**The Reserve at Wyoming Springs - Rezoning**  
**ZONING ZON1802-007**

**DATE OF REVIEW:** March 21, 2018

**STAFF REVIEW AND ANALYSIS:**

TITLE:  
**WYOMING SPRINGS CONCEPT PLAN**

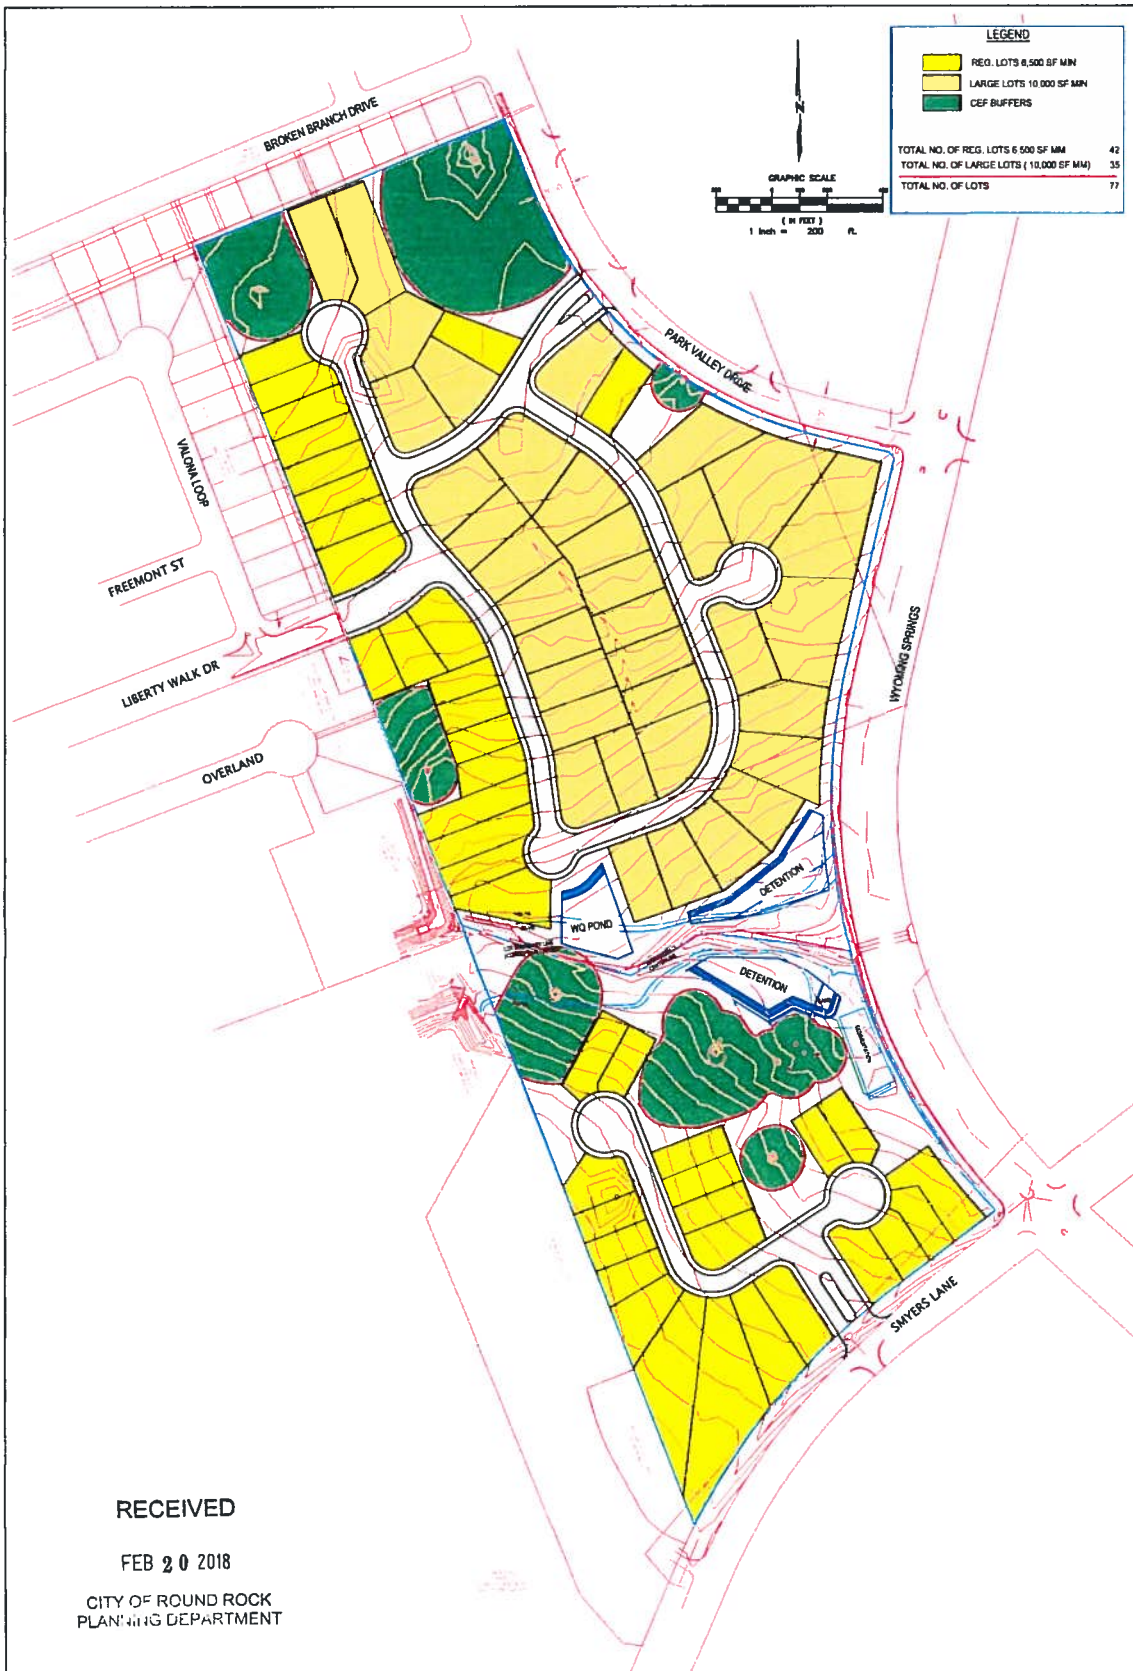
Draft site layout: The draft site layout prepared by the developer indicates that the project will provide both estate lots and standard lots, with no small lots. The layout results in a connectivity index of 1.08, which is less than the minimum requirement of 1.35. The site has several karst features and is crossed by a significant drainage swale, which makes connecting the two parts of the property impractical. The swale contains ultimate 1% annual chance floodplain, which would make a crossing cost prohibitive. The connectivity section of the code allows for an index of less than 1.35 in this situation. The layout also indicates that Liberty Walk Drive, which stubs out on the eastern border of the tract, will be extended across the site to Park Valley Drive.

Staff recommends approval of the rezoning from the OF (Office) district to the SF-3 (Single Family – mixed lot) district.
